Facility Study For Generation Interconnection Request GEN-2014-001 (IFS-2014-001-8)

Generation Interconnection Facility Study

Generation Interconnection Request SPP-GEN-2014-001 SPP-IFS-2014-001-8

Response Comments to: Facility Study for Generation Interconnection Request RE: GEN-2014-001 (IFS-2014-001-8)

Figure 1 – Westar Regional Transmission System

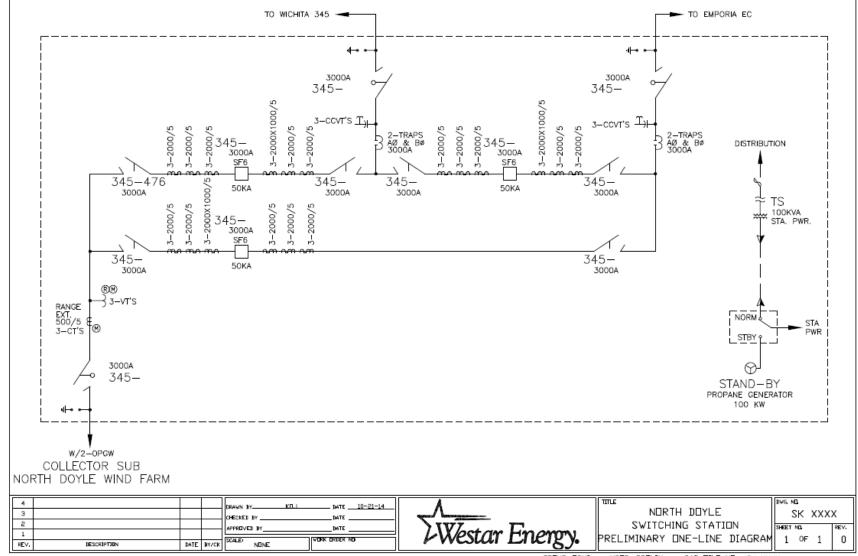
Figure 1, they are showing the old POI. The new location is at the crossing of Highway 77 and 345 KV line (contemplated on the West side of the Highway)

Figure 2 – Interconnection Substation Preliminary One-Line

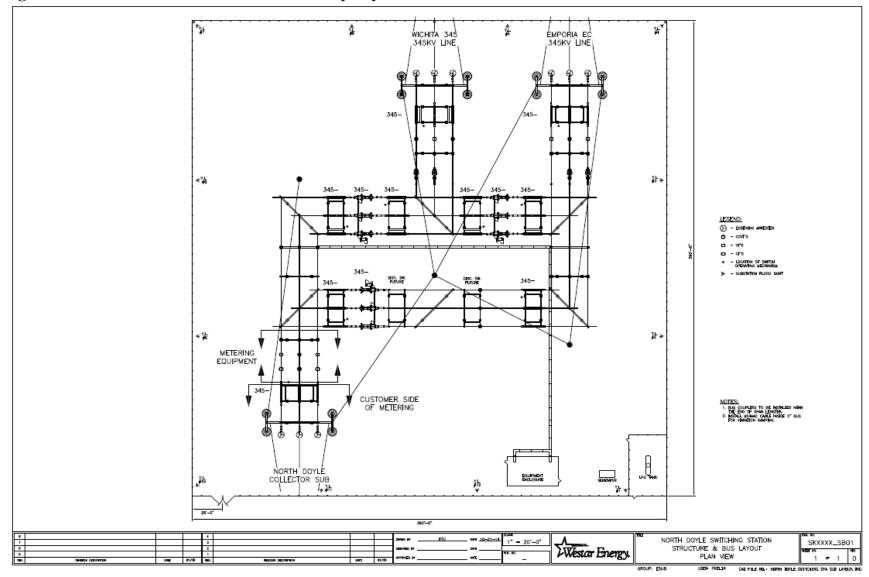
- 0 Ring Bus Substation (no metering or customer equipment included)
 - 3 345 kV Breakers One Line shows 3,000 AMP- Is 2,000 AMP breakers sufficient?
 - 7 345 kV Switches -Only (2) below are broken out as motor operated switches?

- One Line Showing Station Service, We used a generator and assumed power would be brought to interconnection by others, installed and hooked up by
- Control Building Location
 - We had centered the control building which has less control cabling.
